Technical Bulletin

DP08	TB001-DP08-08	Elan Motorsports Technologies	
From:	Chip Lewis		
Subject:	<i>2008 Raised Nose and Damper Cover</i>	Date:	July 24th, 2008

Attention all Elan/Van Diemen RF97 thru DP08 teams

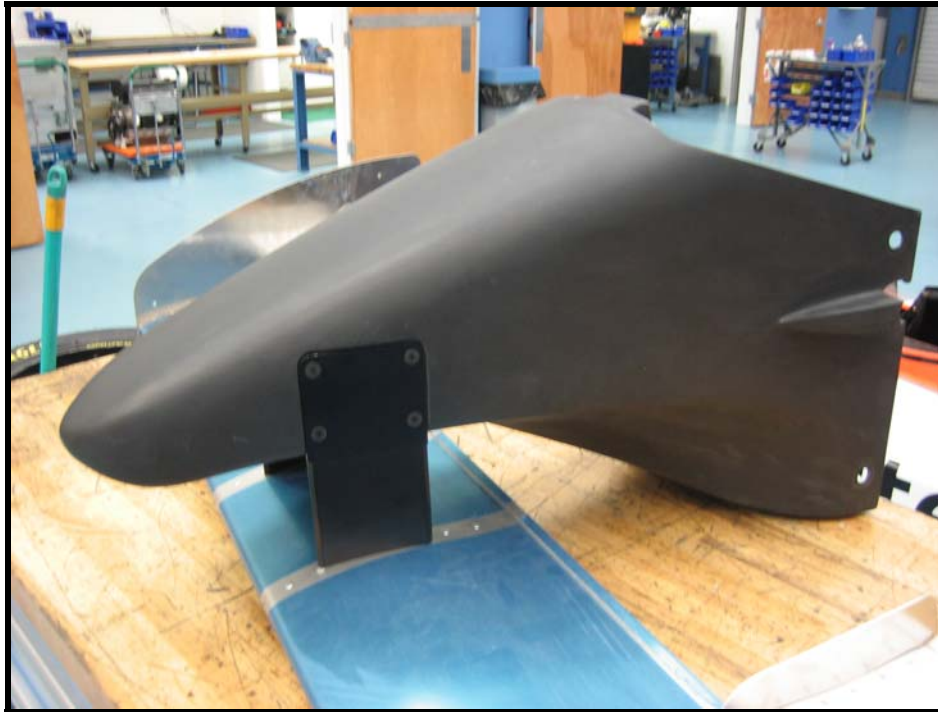
Available to order is a new Raised Nose and Damper Cover, DP08-40-007 and DP08-40-006 respectively. The new nose significantly improves airflow around the nose of the car, improving downforce and reducing drag. The new nose was developed in conjunction with Andersen Racing, and is run on Anders Krohn and Johnny Baker's cars.

This new nose requires new front wing pylons (DP08-40-009 & DP08-40-010). If you are required to run a front crash structure, a new version is available that fits this nose (DP08-40-026).
